Access Compliance Report Public Rights-of-Way (Curb Ramps)

Main Street: ST_IVES_WAY Cross Street: DORRANCE_DR Location: W

ADA ID: RPRK211115114226 Ramp Type: Type 4 - Parallel Initial Pass/Fail: Fail Overall Compliance: No Severity Score: 2

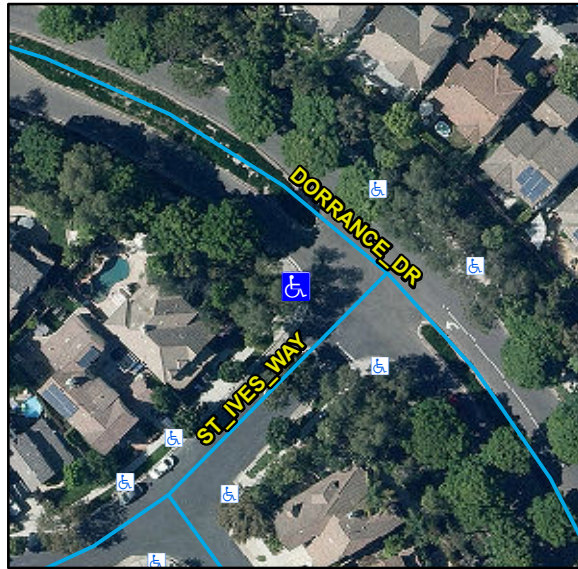
Compliance	Description	Data	Compliance	Description	Data
N/A	Ramp Length LT (in)	134	N/A	Ramp Length RT (in)	146
Yes	Ramp Width LT (in)	88	Yes	Ramp Width RT (in)	88
Yes	Ramp Run Slope LT (%)	2.7	Yes	Ramp Run Slope RT (%)	5.2
No	Ramp Cross Slope LT (%)	4.6	No	Ramp Cross Slope RT (%)	2.8
N/A	Landing Present	N/A	N/A	DWS Provided	N/A
N/A	Landing Length (in)	N/A	N/A	DWS Contrast	N/A
N/A	Landing Width (in)	N/A	N/A	DWS Length (in)	N/A
N/A	Landing Run Slope (%)	N/A	N/A	DWS Full Width	N/A
N/A	Landing Cross Slope (%)	N/A		DWS Offset Type	N/A
N/A	Landing Movement Obstructed?	N/A	N/A	DWS Offset Left (in)	N/A
	Landing Movement Type	N/A	N/A	DWS Offset Right (in)	N/A
N/A	Landing Shared	N/A			
N/A	Clear Space	Yes			
N/A	Clear Space To Crosswalk (in)	N/A			
N/A	Marked Crosswalk 1	No	N/A	Marked Crosswalk 2	No
	Crossing 1 Direction	SE		Crossing 2 Direction	NE
	Marked Crosswalk 1 Width (in)	N/A		Marked Crosswalk 2 Width (in)	N/A

Remove & Replace Curb Ramp With Two New Directional Ramps or Equivalent.
